FAQ Number 07-0036

FAQ Title Incorporation of Pilot Plant Lessons Learned - Table B-1

Plant: Harris

Date: July 16, 2007

Figure 4-2 - Fundamental Program and Design Elements Transition Process (Simplified)

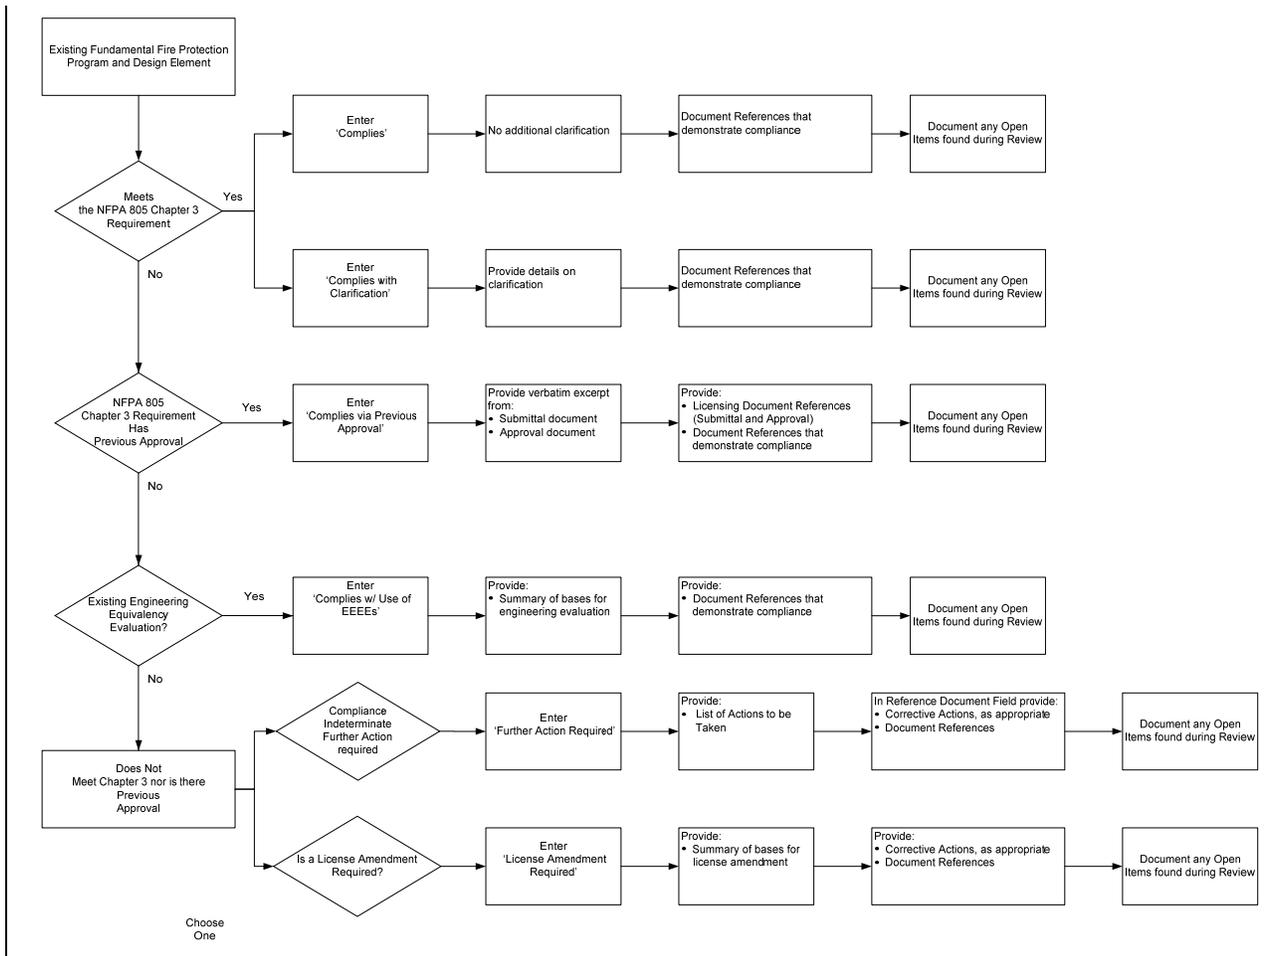
Guidance needs to be provided to document the specific compliance categories assigned and methodologies used during the Chapter 3 review, and to update Figure 4-2 to reflect the process used by the pilot plants.

A ~~simplified~~ flowchart of the fundamental program and design elements transition review is provided as Figure 4-2.
